# Warrenton Horse Show Observations

WHITMAN, REQUARDT AND ASSOCIATES MONDAY, 3/20/2023

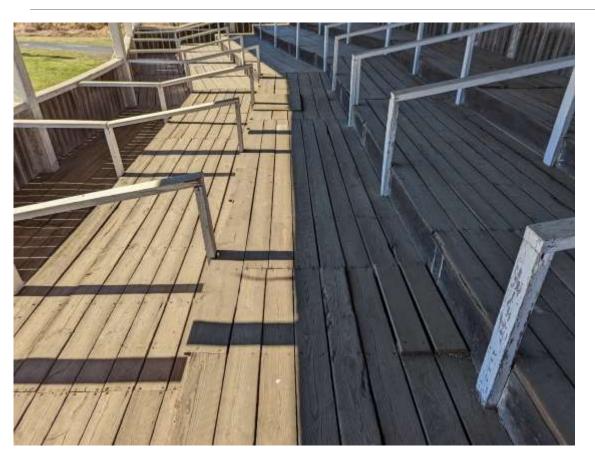
- Wood post connected to pier with metal plate
- The metal has rusted over time and cause expansion.
- The expansion has caused the pier to spall.

- Metal strap connecting to wood post
- Spalls where the plate was embedded in pier

## Seating Area Perimeter Barrier

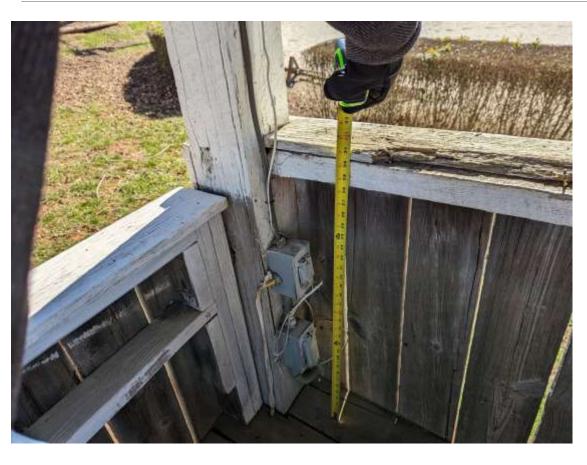
- Need barrier at perimeter of seating area to be 42" for fall prevention
- Existing barriers are approximately 31" and would need to be extended.
